Certificate of Appropriateness

2451 - 57 N. TERRACE AV. & 2727 – 29 BRADFORD AV
NORTH POINT NORTH HISTORIC DISTRICT

114465 COA: landscaping, driveway, fences, & dormer

APPROVED
By Tim Askin at 9:29 am, May 22, 2018

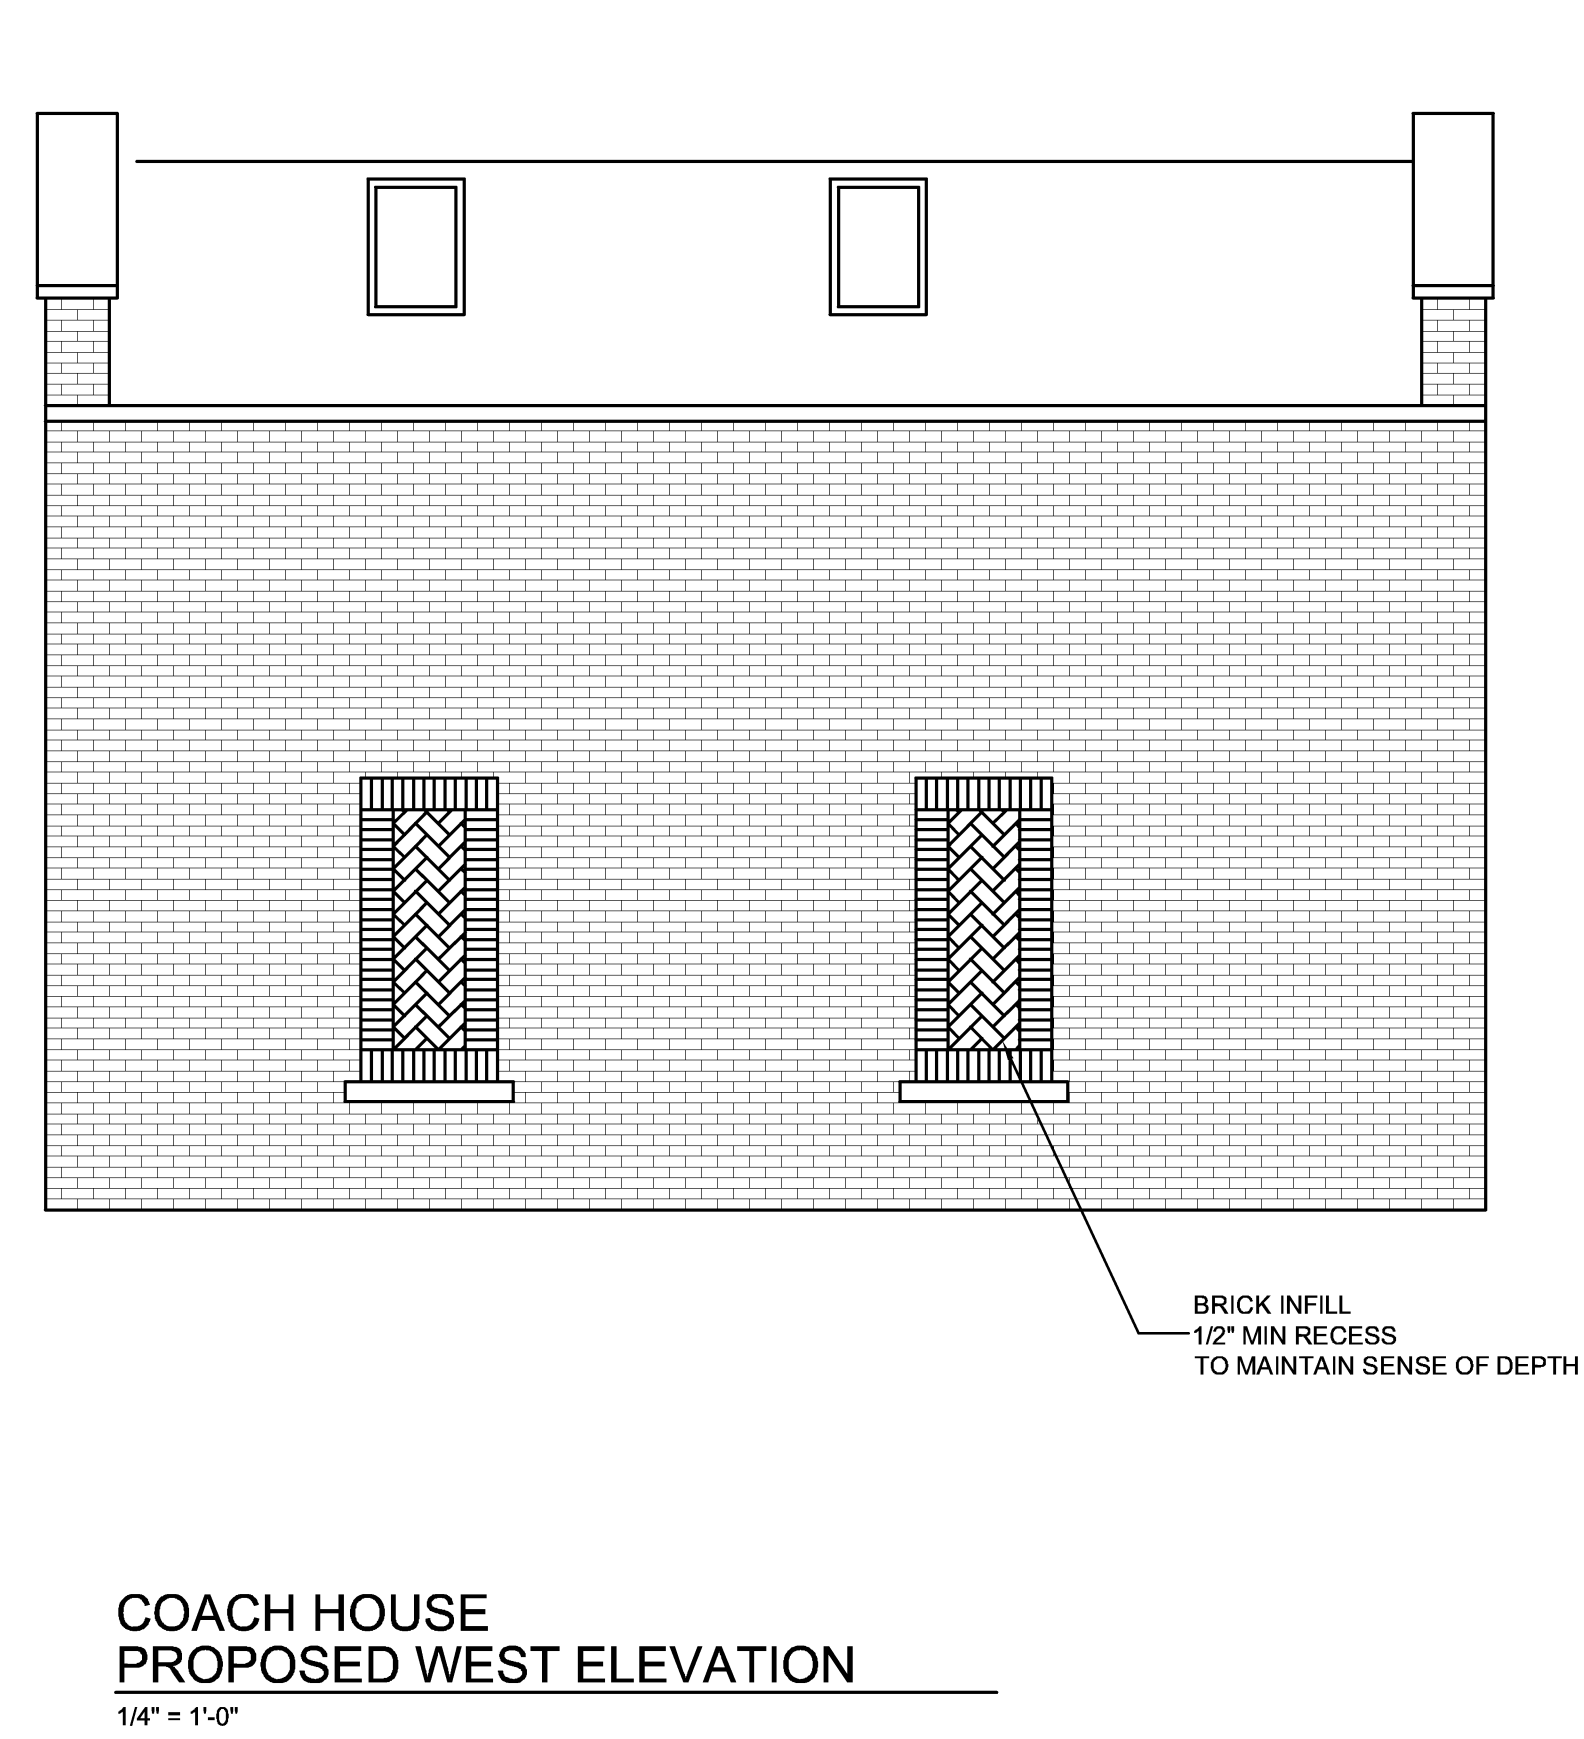
Remodel two courtyard sides of Coach House new fenestration and repairs to masonry. Remaining 2 sides of coach house are located 6" from the property line, therefore no combustible materials will be used on these walls, existing brick to remain. Enclose with brick panels that are recessed 1/2" from main wall (Pages A104 and A105).

- C. **Standard Masonry conditions:** New mortar must match the original mortar in terms of color, texture, grain size, joint width, and joint finish/profile. The compressive strength of the repointing mortar shall be equal or less than the compressive strength of the original mortar and surrounding brick or stone. The replacement mortar shall contain approximately the same ingredient proportions of the original mortar. Mortar that is too hard is subject to premature failure and could damage the masonry. In most cases, this means a lime mortar with natural hydraulic cement rather than Portland cement. No joint of a width less than 3/8" may be cleaned of damaged/decomposed mortar with power disc grinders. No over-cutting of the joints is permitted. Remove decomposed mortar back into the wall 2.5 times the height of the joint before tuckpointing.
New brick must match as closely as possible the color texture, size, and finish of the original brick. A sample panel of brick and mortar must be reviewed and approved by HPC staff prior to general installation of the material.
